**ADDENDUM #1
BL079-25**

Replacement of Odor Control Fans at the F. Wayne Hill Water Resources Center

The following addition/changes modify the Bid No. BL079-25 "Replacement of Odor Control Fans at the F. Wayne Hill Water Resources Center" Contract Documents, dated June 2025, as first advertised on June 11, 2025.

DESIGNED: RAMSEY	CHECKED:	DATE: JAN 2002	2-20 M-102	R
DRAWN: RAMSEY	APP'D.	SCALE: 1/8"=1'-0"	DRAWING	REV

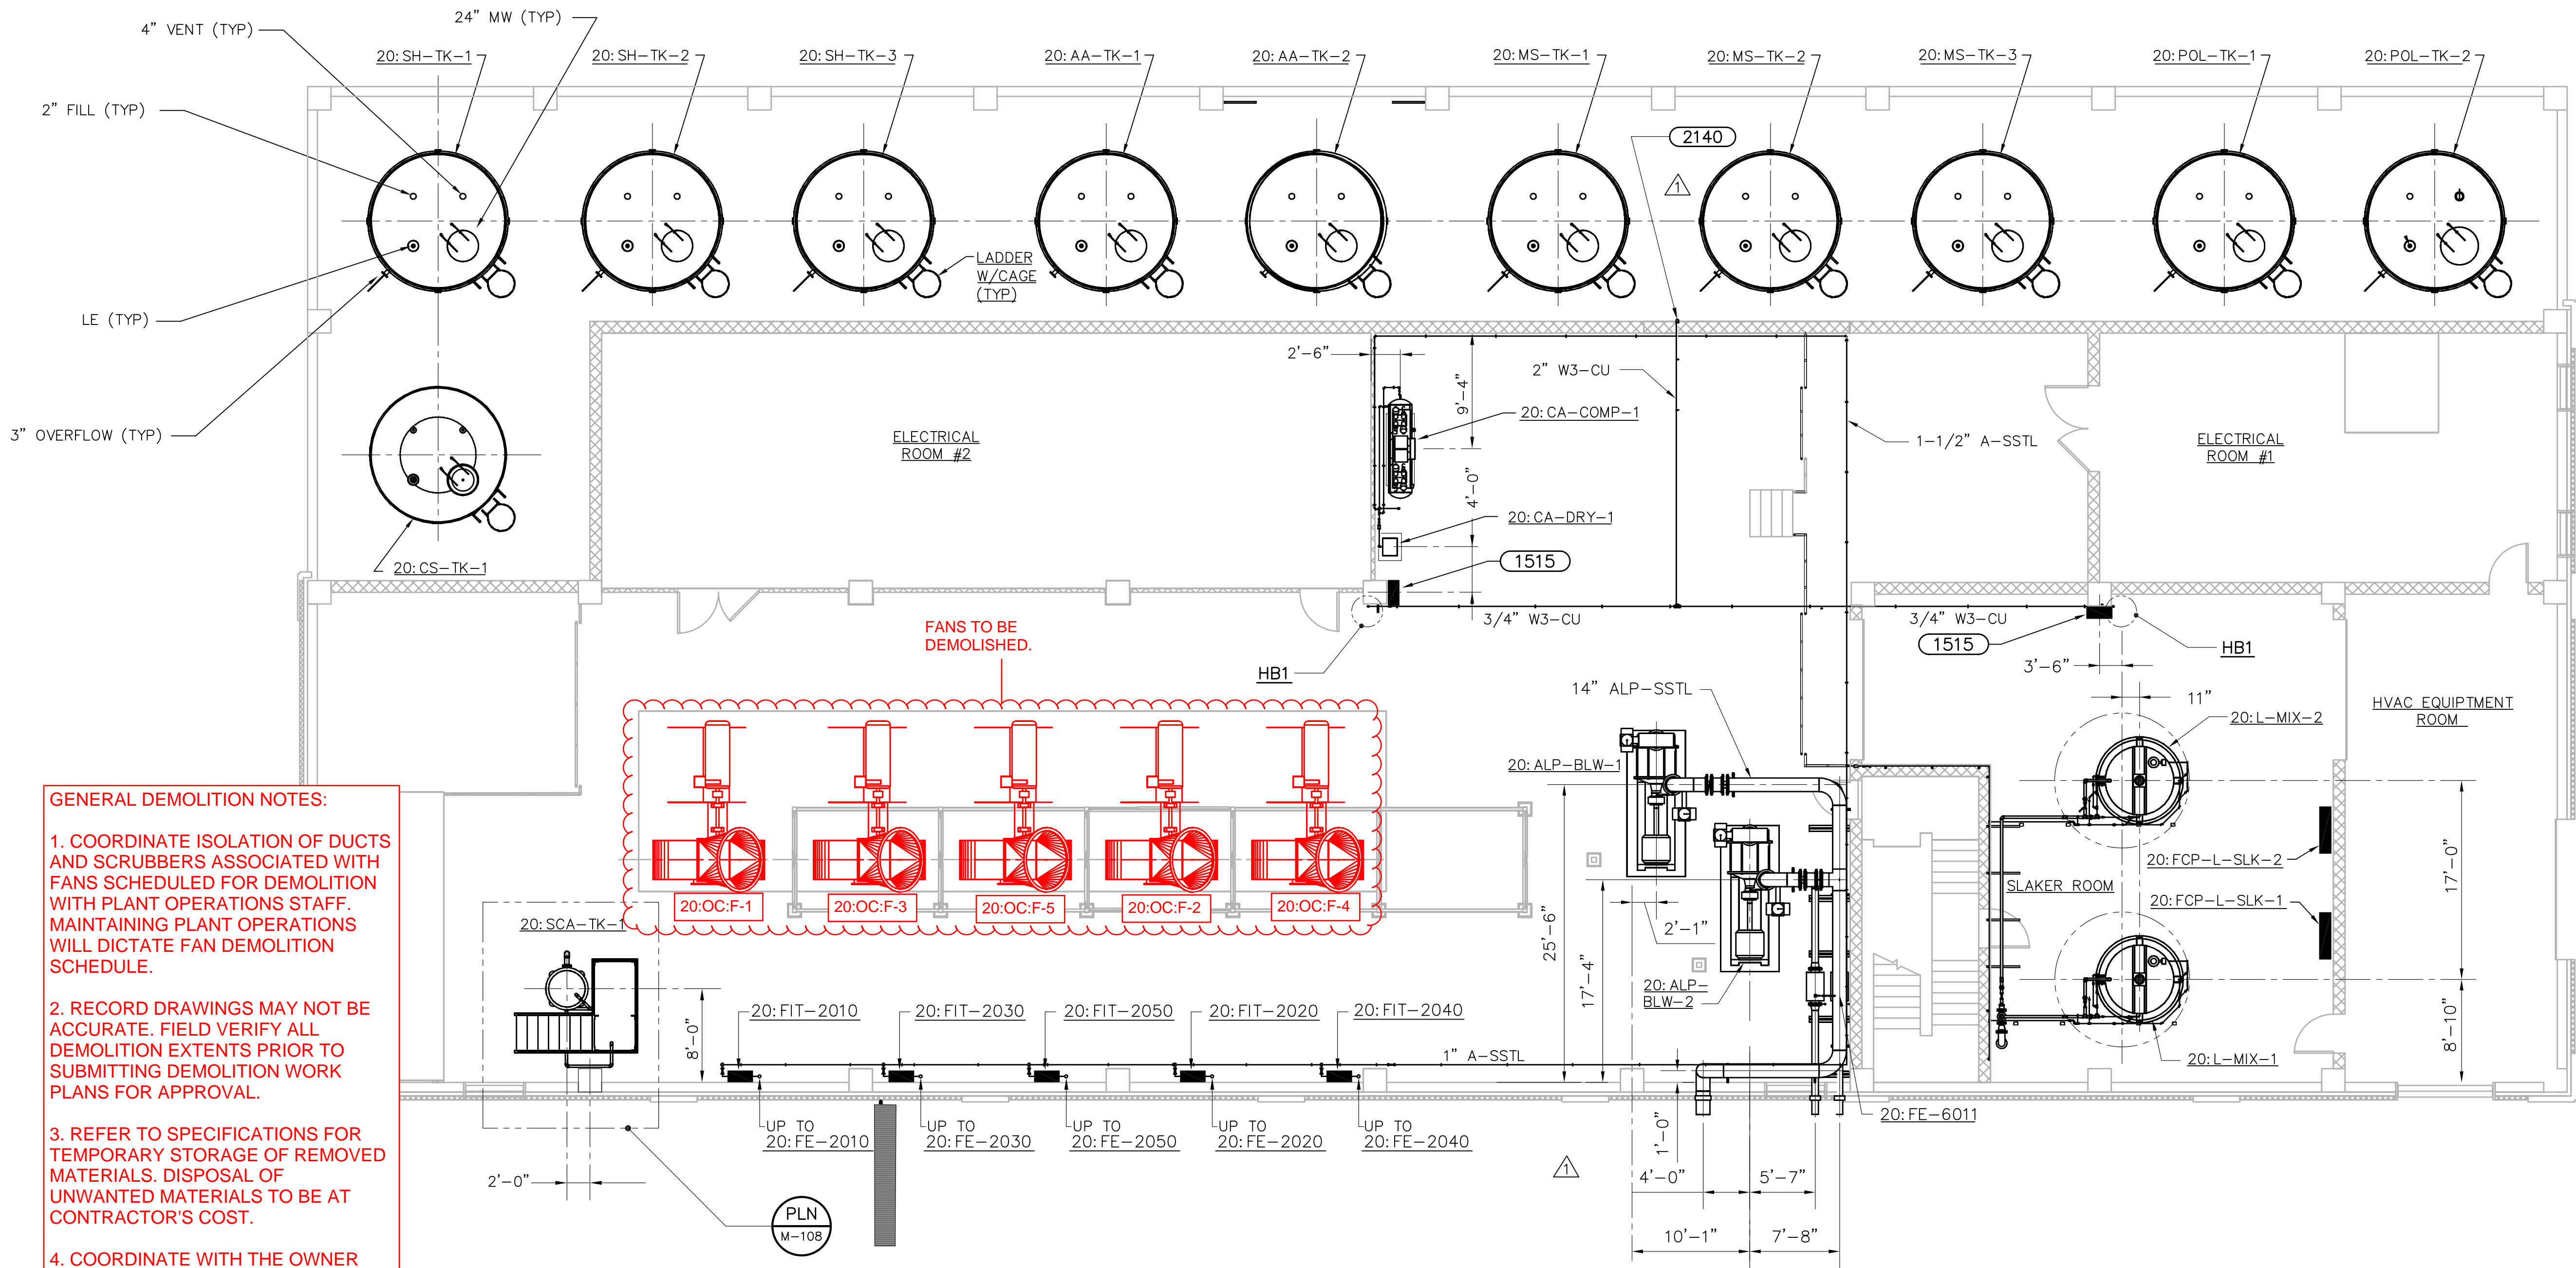
- Q7. Exhibit A Drawing 2-20 M-102 does not show any highlighting or color changes as was done on drawing 2-20 H-105. It also does not call out the fans but we believe that the five fans are the grey devices in the middle of the largest room shown. Please confirm that these are the fans that are to be replaced.**

- A7. Same note as A.6. Some of the file markups were corrupted when the individual files were compiled into one document. We had not realized the markups disappeared from the Exhibits. See attached revised Exhibits with markups.

DESIGNED: RS	CHECKED:	DATE: JAN 2002	2-20 H-102	R
DRAWN: DCH	APP'D.	SCALE: 1/8"=1'-0"	DRAWING	REV

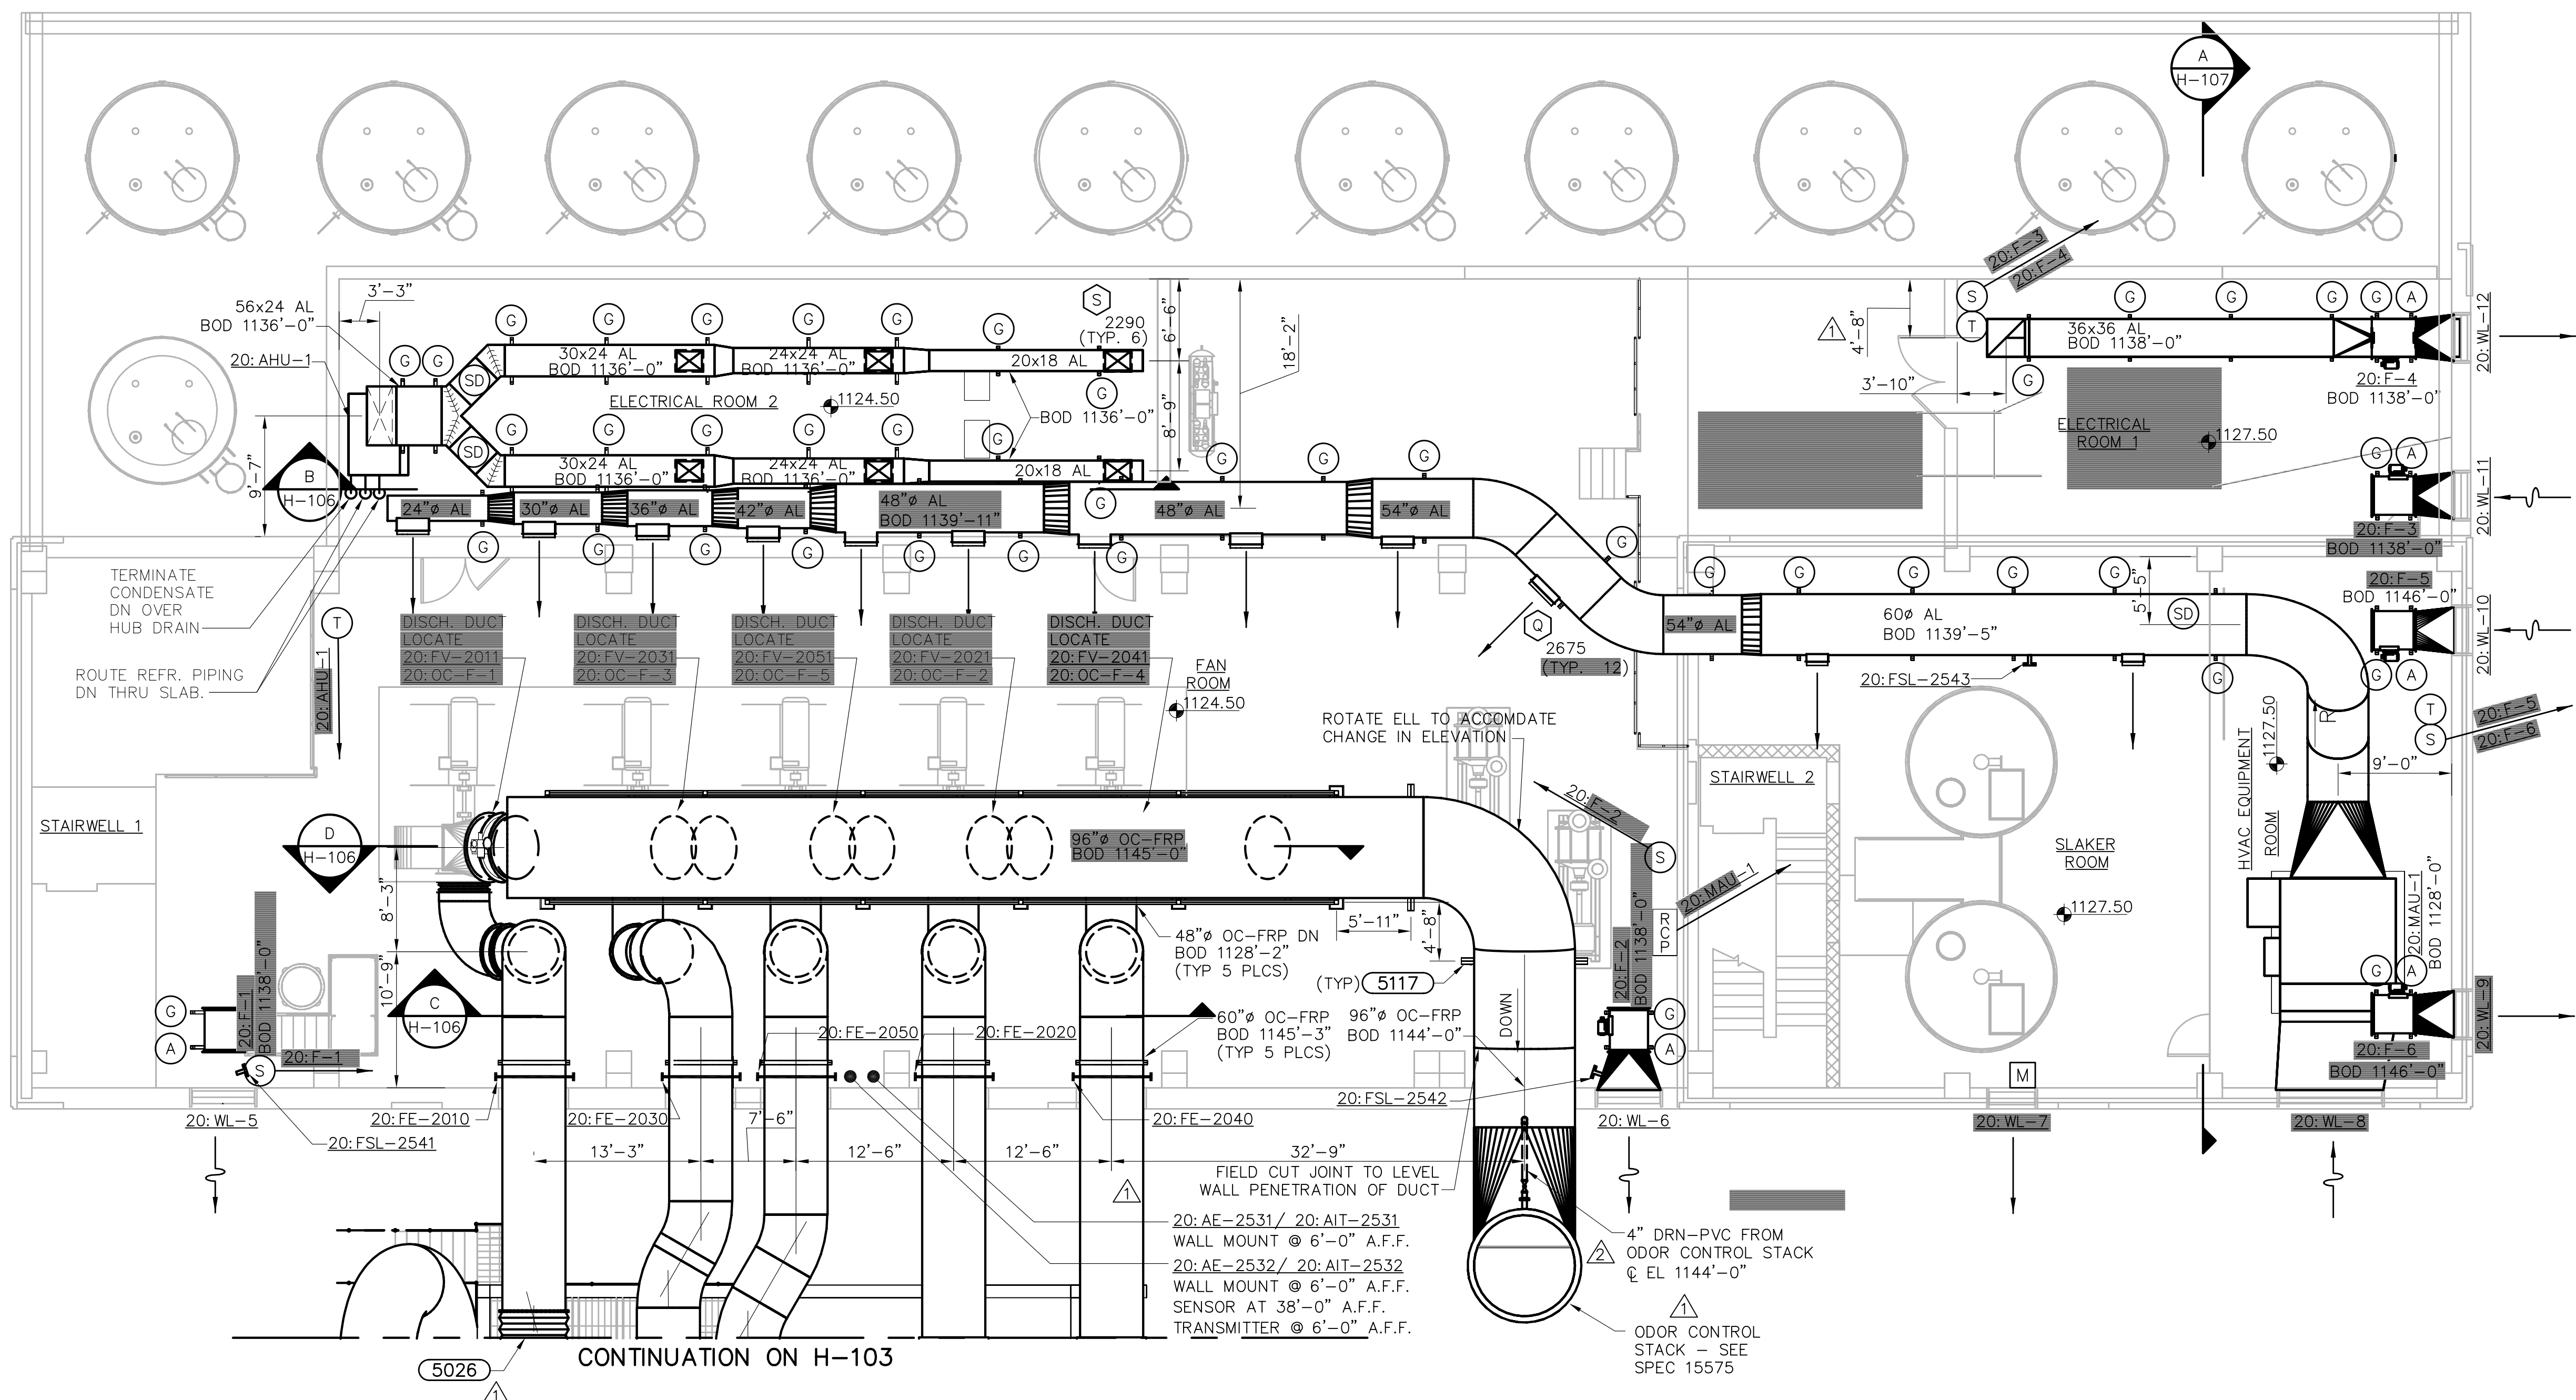
- Q8. Exhibit A Drawing 2-20 H-105 seems to show that this section is from drawing H-103. Can this drawing as well as any other H drawings showing this room be provided for additional information?**

- A8. Drawing sheet H-103 does not provide much clarity as it simply depicts the scrubbers outside of the building, but it has been provided in the updated Exhibit A, along with sheet H-102 which actually shows the inside of the building.

DESIGNED: RS	CHECKED:	DATE: JAN 2002	2-20 H-105	R
DRAWN: DCH	APP'D.	SCALE: AS NOTED	DRAWING	REV

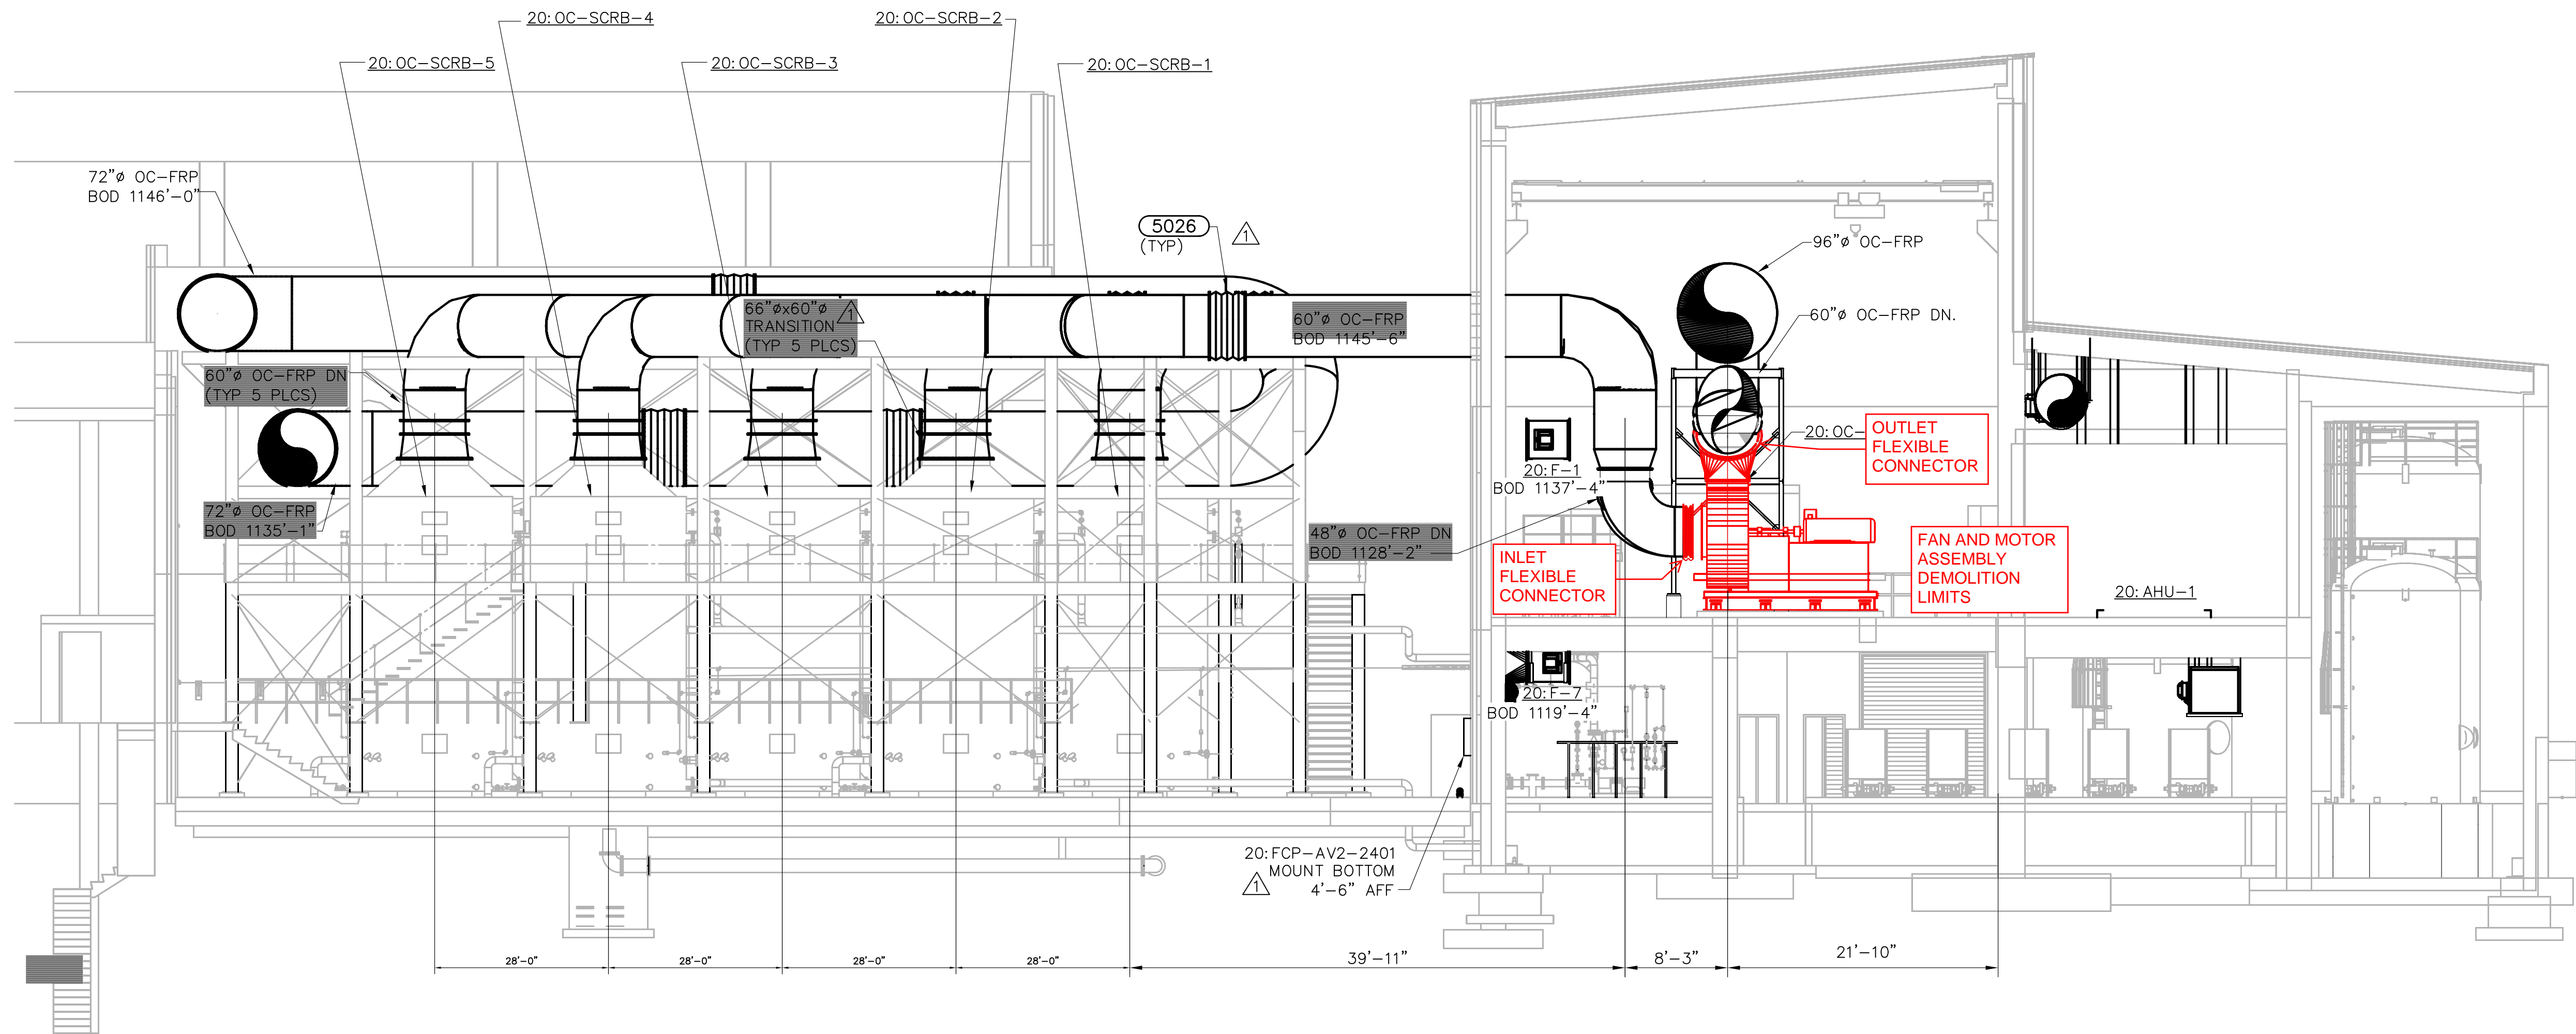
Q9. Exhibit A Drawing 2-20 H-105 has the fan and the motor highlighted in red, we assume that this is done to indicate the scope of demolition. Please confirm that the motor base frame is not to be replaced.

Q10. Exhibit A Drawing 2-20 H-105 shows within the fan room there is a bridge crane, can the contractor utilize the bridge crane for our work? What is the capacity of this bridge crane? Mandatory training video to be watched? Inspection at the completion of the work?

Q11. Exhibit A Drawing 2-20 H-105 does not specifically call it out but there is a square to round transition duct on the discharge side of the fan between the fan sections and the rubber expansion joints, that are being replaced per specification. It is shown as red, does this piece need to be replaced or can it be reused.

A9. The motor base frame must be replaced as well.

A10. Yes, the crane can be used to move equipment in and out of the building. The crane has a capacity of 7 tons according to the O&M manual we have on record. Contractor is allowed to operate the crane by themselves, but they must follow all the safety precautions and ensure the weight of the equipment is within the crane tolerance.

A11. Bidders must plan to replace everything between the flex connectors.
